Subject: **Bid #: 8491-J6, Salisbury Street Culvert Replacement (S25-4) / DPW**

ADDENDUM NO. 2

CITY OF WORCESTER, MASSACHUSETTS
SALISBURY STREET CULVERT REPLACEMENT

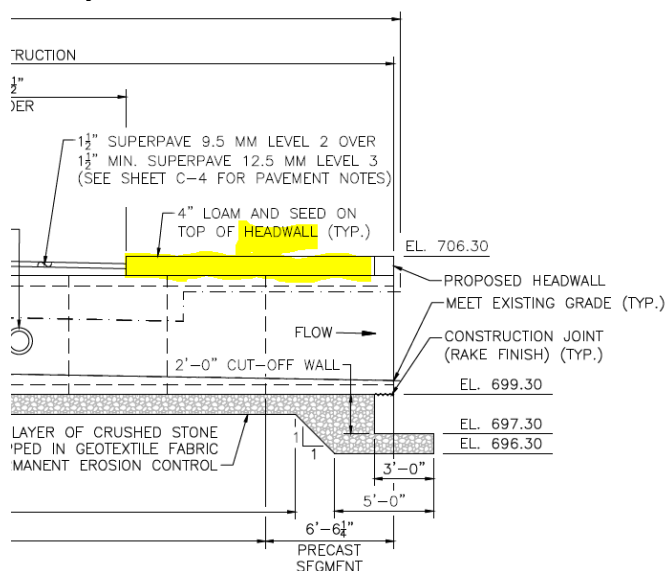
Q10. Specification page 10 states stream flow management plan should consider up to a 2.5-year flood event. Can the gallons per minute flow rate for the 2.5-year storm be provided so that the contractor can design for it?

A10. **The Contractor is responsible for the design of the stream flow management assuming full flow conditions through the existing culvert.**

S-6R

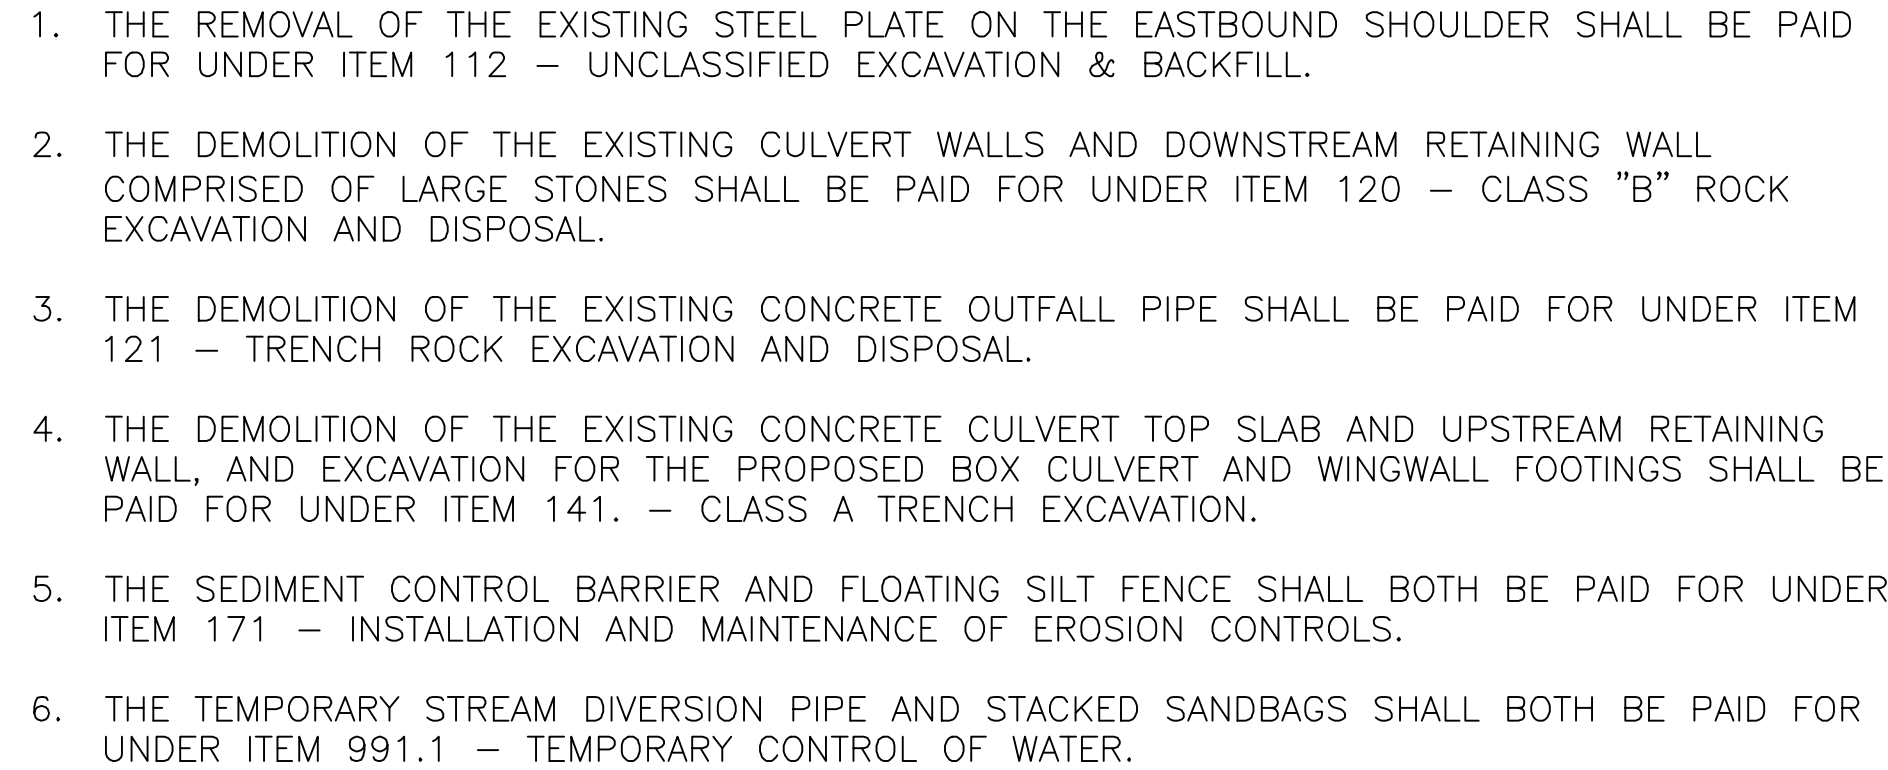
Q12. Can you please clarify what you are looking for here (ref page S-8, Longitudinal Section Looking East). The note says the Loam and Seed go over the Headwall. The drawing appears to have it directly on top of the culvert roof. Can you confirm that that is the case (directly on top of the culvert) or if you indeed want to carry the headwall back that far (10' ish) then would it be CIP in the field since we cannot cast a continuous slab over multiple sections of culvert at the factory.

A12. The area of the culvert between the headwall and edge of pavement is to be backfilled and have 4-inches of loam and seed placed over the backfill. The section has been revised to clarify this condition and is provided as part of this addendum.
